Fuse Blocks & Circuit Breakers

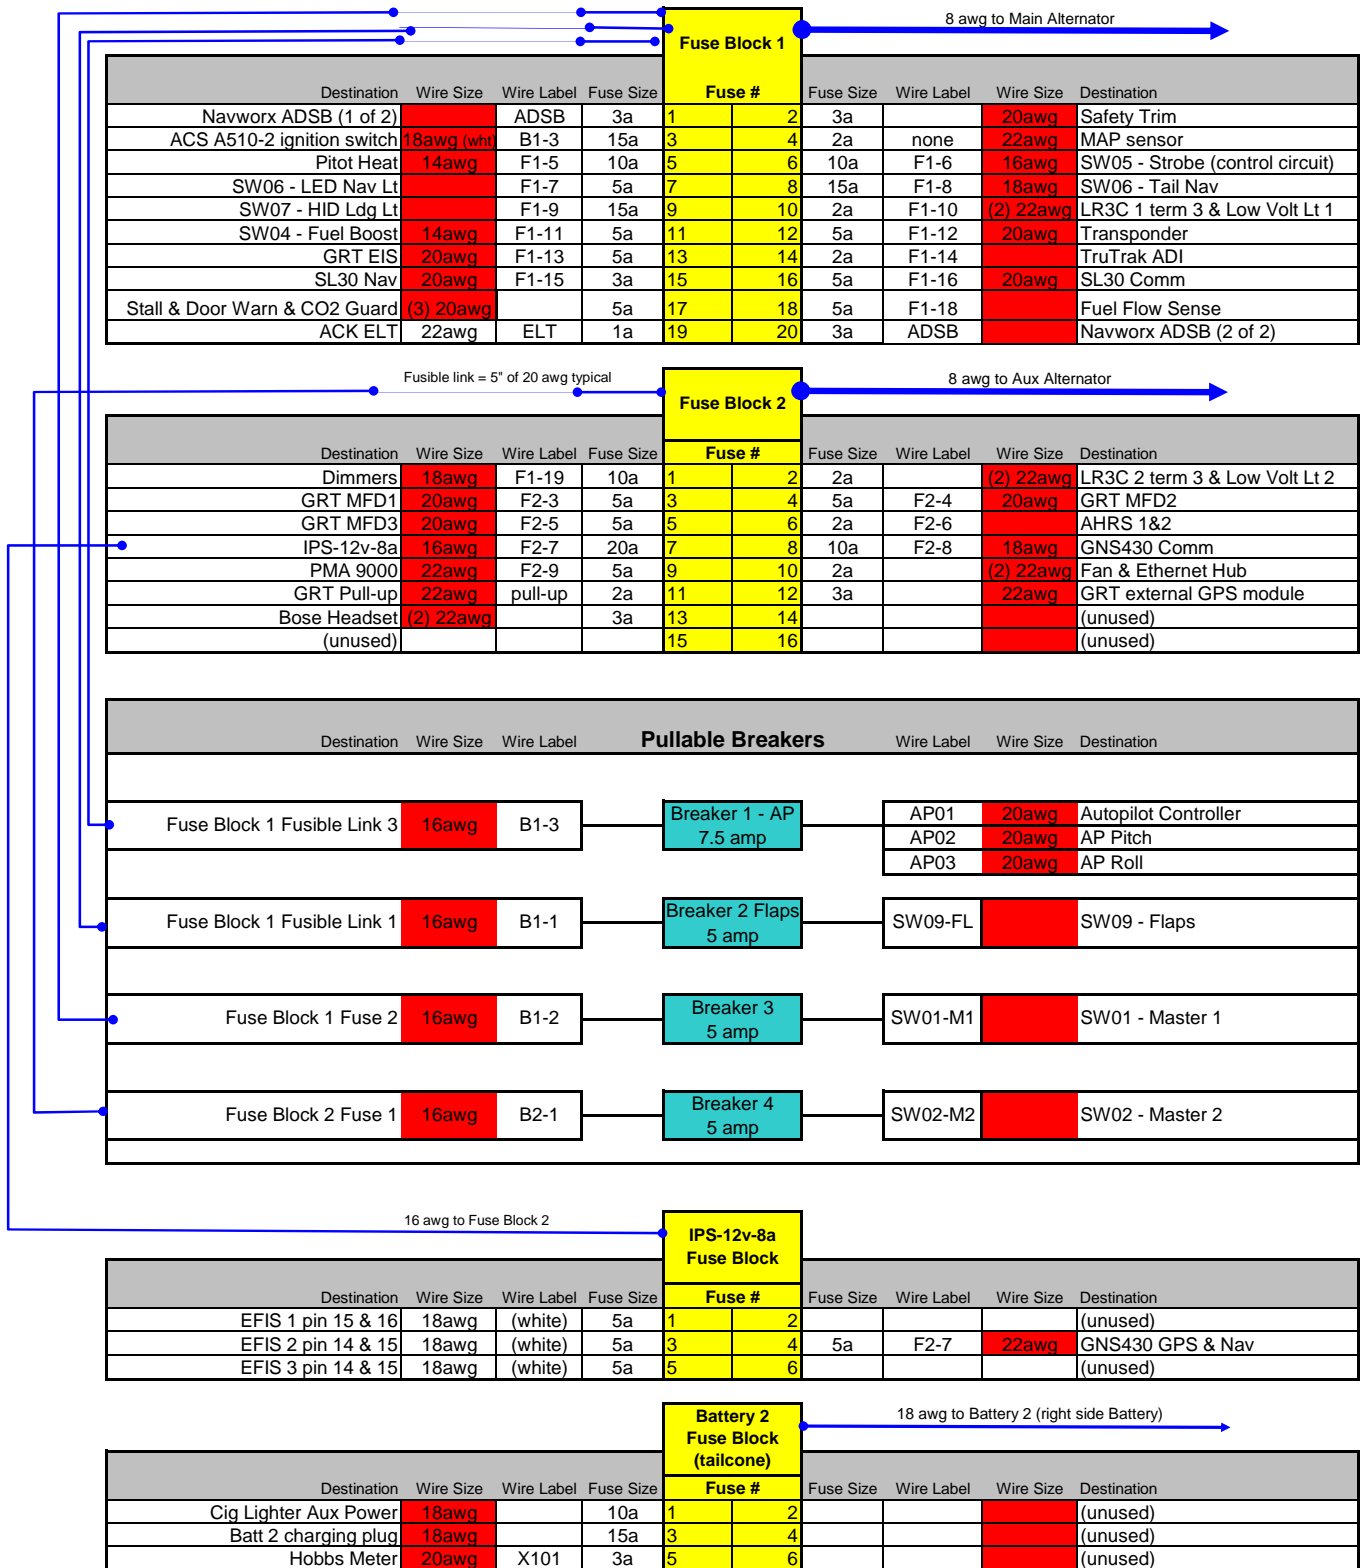
- 4.0 Swapped ADSB from Bus 2 to Bus 1
- Swapped AP from Bus 2 to Bus 1
- Added Intelligent Power Stabilizer IPS-12v-8a for G430 and (3) GRT EFIS
- 4.1 Removed GRT Clock power from Batt 2 Fuse Block
